Well Name: DAVIS	Well Location: T26N / R8W / SEC 5 / SWSE / 36.51135 / -107.70232	County or Parish/State: SAN JUAN / NM
Well Number: 2	Type of Well: CONVENTIONAL GAS WELL	Allottee or Tribe Name:
Lease Number: NMSF078430	Unit or CA Name:	Unit or CA Number:
US Well Number: 3004505995	Operator: HILCORP ENERGY COMPANY

Subsequent Report

Type of Submission: Subsequent Report      Type of Action: Plug and Abandonment

PLUG AND ABANDONMENT

## Current Schematic - Version 3

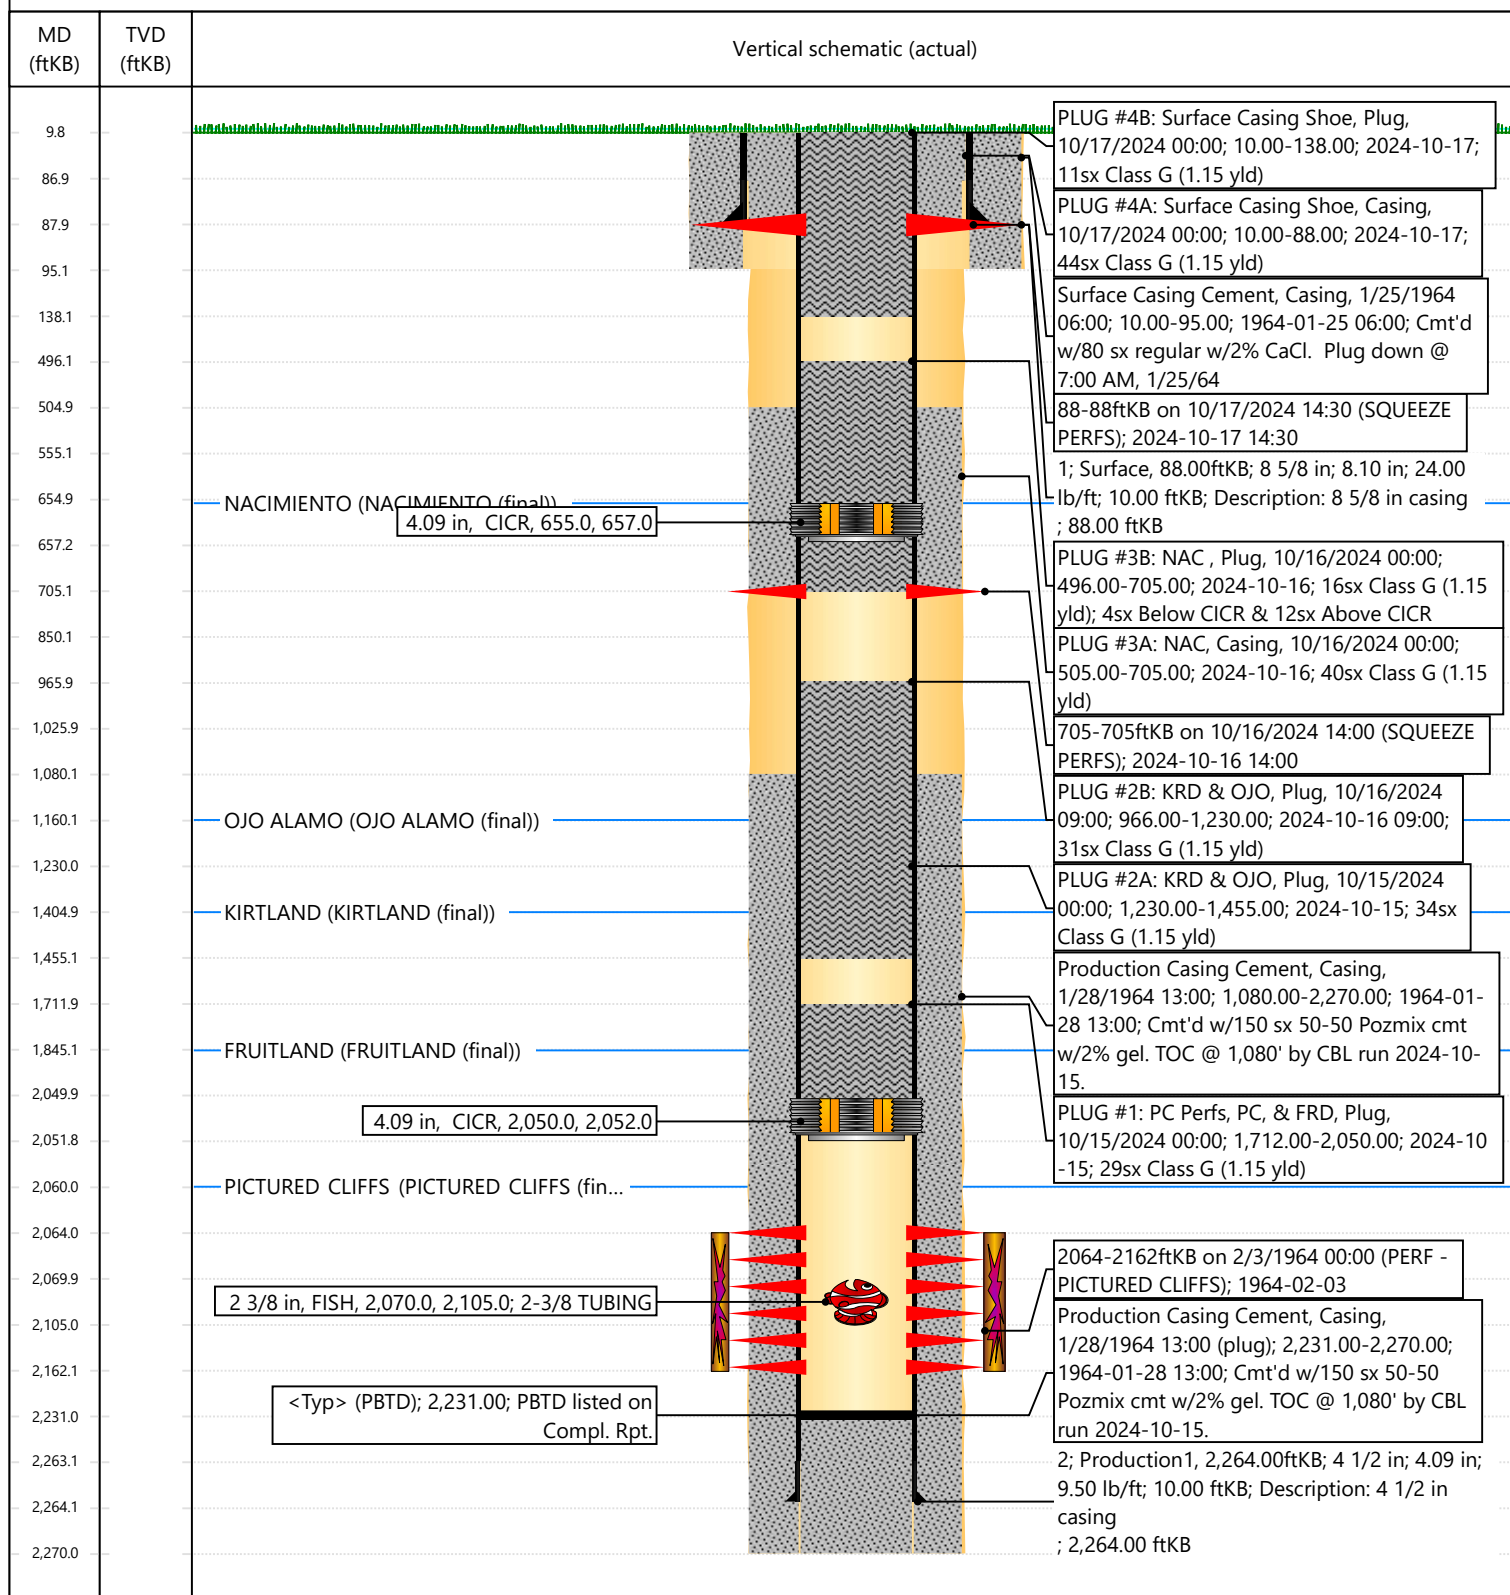
Per our conversation this morning, we RIH & tagged PLUG #2 low @ 1,230' this morning after WOC overnight.

Moving forward, the NMOCD and BLM provided verbal approval to top off PLUG #2 by pumping PLUG #2b:

- 14sx Class G (1.15 yld) inside the 4-1/2" casing - Est. **TOC @ 1,060'** & Est. **BOC @ 1,230'**.
- WOC & Tag

Attached is the CBL run today (2024-10-15) on the Davis 2. It shows a TOC @ ~1,080'.

- PLUG #3: 52sx of Class G Cement (15.8 PPG, 1.15 yield); NAC Top @ 655':
  - TIH & perforate squeeze holes @ +/- 705'. RIH w/ 4-1/2" CICR and set CICR @ +/- 655'. TIH w/ work string & sting into CICR. Establish injection.

- Pump 40sx of cement in the 4-1/2" casing X 7-7/8" open hole annulus (est. TOC @ +/- 505' & est. BOC @ +/- 705'). Pump an additional 4sx of cement beneath the 4-1/2" CICR (est. TOC @ +/- 655' & est. BOC @ +/- 705'). Sting out of retainer, pump an 8 sack balanced cement plug on top of the CICR. (est. TOC @ +/- 555' & est. BOC @ +/- 655').

- WOC for 4 hrs, tag TOC w/ work string. \*Note cement plug lengths and volumes account for excess.
- PLUG #4: 30sx of Class G Cement (15.8 PPG, 1.15 yield); Surf. Casing Shoe @ 88':

- TIH & perforate squeeze holes @ +/- 88'. Establish circulation.
  - TIH w/ work string to 138'
  - Pump 19sx of cement in the 4-1/2" casing X 8-5/8" casing annulus (est. TOC @ +/- 0' & est. BOC @ +/- 88'). Pump an 11 sack balanced cement plug inside the 4-1/2" casing (est. TOC @ +/- 0' & est. BOC @ +/- 138').

- WOC for 4 hrs, tag TOC w/ work string.
- Cut off wellhead/top off all strings. Weld on P&A marker.

After moving on, we found that the tubing was stuck. After making several attempts to free the pipe, we ran a free point tool. We found that the tubing was 100% free @ 2,085'. The NMOCD and BLM then gave Hilcorp verbal approval to jet cut the tubing

@ 2,070' (just above the collar) and proceed with the approved NOI, leaving ~35' of tubing below the NOI approved CICR set depth @ 2,050'.

NMOCD approves below

To confirm the BLM finds the procedure appropriate.

NMOCD approves below

To confirm, the BLM finds the proposed procedure appropriate.

NMOCD approves below

To confirm, the BLM finds the procedure appropriate.
